THE COTEAU PROPERTIES COMPANY

June 19, 2018

This letter is in response to your letter dated May 14, 2018. Provided are responses to each of the following questions or requests.

RECEIVED	C.N.	9			 FREEDOM MINE BEULAH, ND 58523
		8			
		7			
		6			
		5			
		4			
		3			
		2			
		1			
		0			
					FIGURE 2 AERIAL PHOTO JULY 2, 1996
					SCALE: 1"=400' PAPER SIZE 11"x17" PROJECT: REVISION:

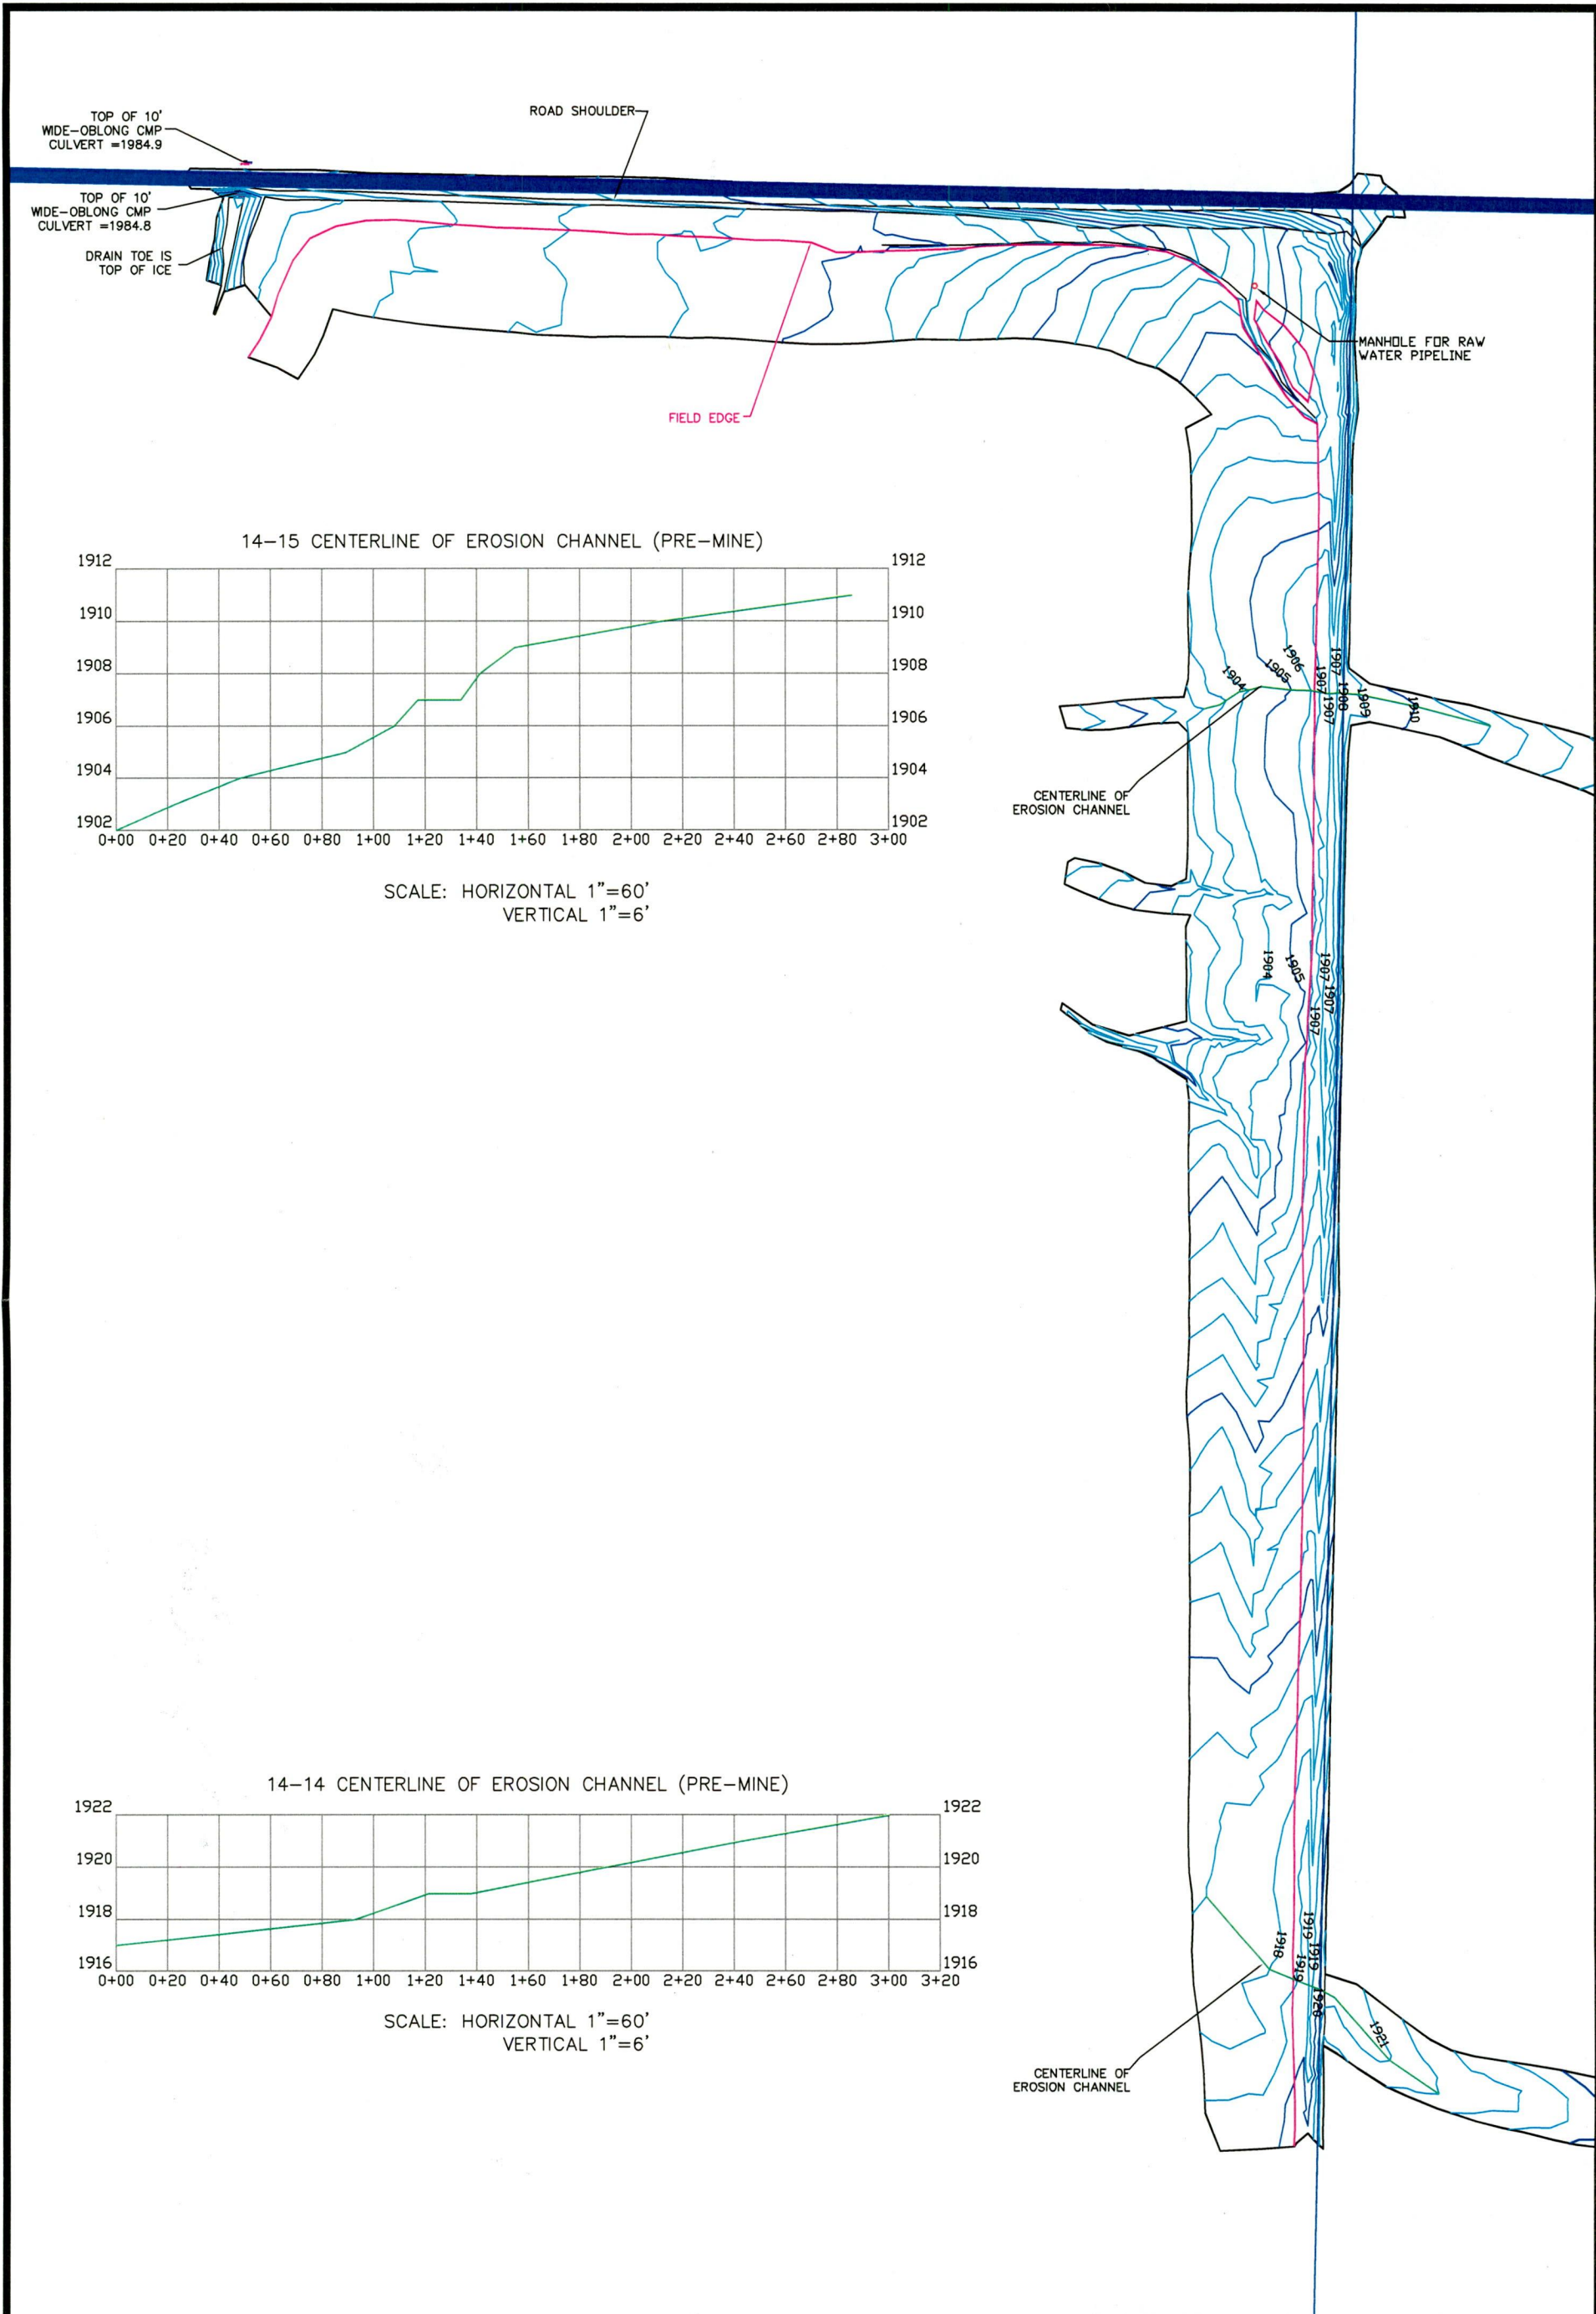
- 1. What was the condition of the pre-existing north/south diversion between the NE $\frac{1}{4}$ and NW $\frac{1}{4}$ of Section 34 and the pre-existing road ditch on the south side of the road between the NE $\frac{1}{4}$ NW $\frac{1}{4}$ of Section 34 and the SE $\frac{1}{4}$ SW $\frac{1}{4}$ of Section 27 prior to reconstruction? Were these features in functional condition and capable of handling the flows from the premine watershed?***

3. *Is there evidence that the original diversion overtopped during mining and reclamation (i.e., prior to being reconstructed)?*

The diversion was not capable of handling pre-mining flows. This is evident by the erosion shown in Figures 1 and 2, attached. Figures 1 and 2 are aerial photographs of the field from 1977 and 1996 respectively.

It should be noted that flows during mining and following mining are less than the flows which occurred pre-mining. It should also be noted that erosion and flooding occurred in the subject field long before mining, as can be shown by viewing aerial photos, including Figures 1 and 2, dating back several decades prior to Coteau entering the area.
